Re: Baffinland Response to Comments Received for Baffinland's Production Increase Proposal Extension 2021 Annual Monitoring Report

Attachment 1 - Baffinland Response to Reviewer Comments by Agency

Table A.1: Response to QIA Comments on Baffinland’s 2021 Annual Report to the NIRB

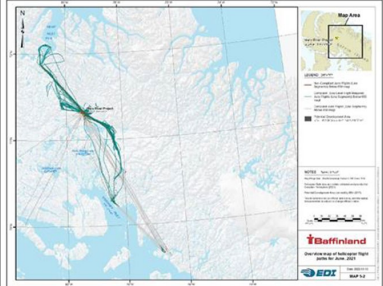
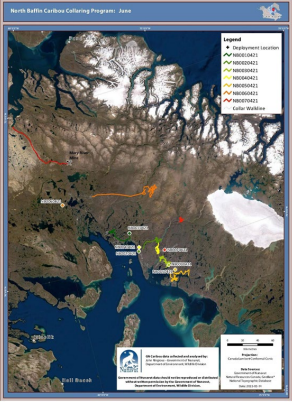
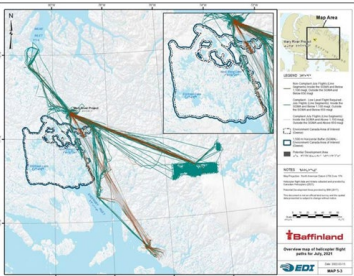
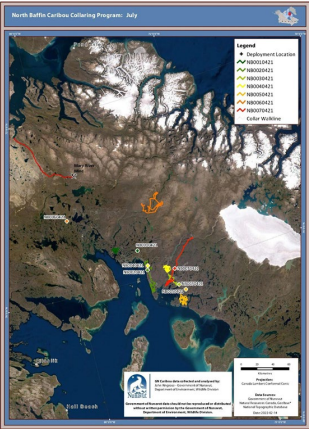
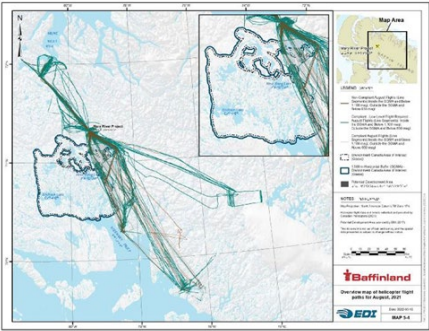
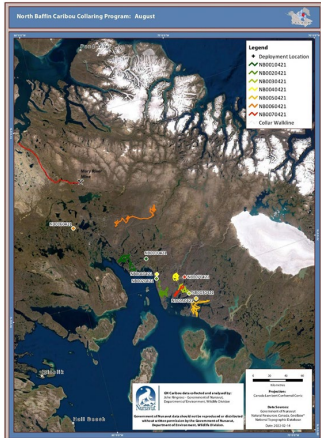
Cmt. #	GN Cmt. #	Reviewer’s Detailed Comment	GN Recommendations	Reference Section	Baffinland’s Response												
		<p>caribou; 32 within the Project Development Area (PDA) and 186 outside the PDA, some of which were in the RSA (EDI 2015, 2016, 2017, 2018, 2019, 2020, 2021).</p> <p>Additionally, in 2021, a small sample of north Baffin caribou were collared by the GN. Although the collars were not deployed in the vicinity of the Project for the purpose of studying Project- related effects, it is apparent that the movements of some individuals overlapped significantly with the Project activities reported in the 2021 Annual Report, such as low-level helicopter flights during calving and post-calving periods in June, July, and August (Compare figures 1-3 below with Maps 5-2 to 5-4 in EDI 2022a).</p>

<table><tr><th>Month</th><th>Caribou Movements</th><th>Helicopter Flights</th></tr><tr><td>June</td><td>See Figure 1 (b) below</td><td>Map 5-2 (EDI 2022a)</td></tr><tr><td>July</td><td>See Figure 2 (b) below</td><td>Map 5-3 (EDI 2022a)</td></tr><tr><td>August</td><td>See Figure 3 (b) below</td><td>Map 5-4 (EDI 2022a)</td></tr></table>
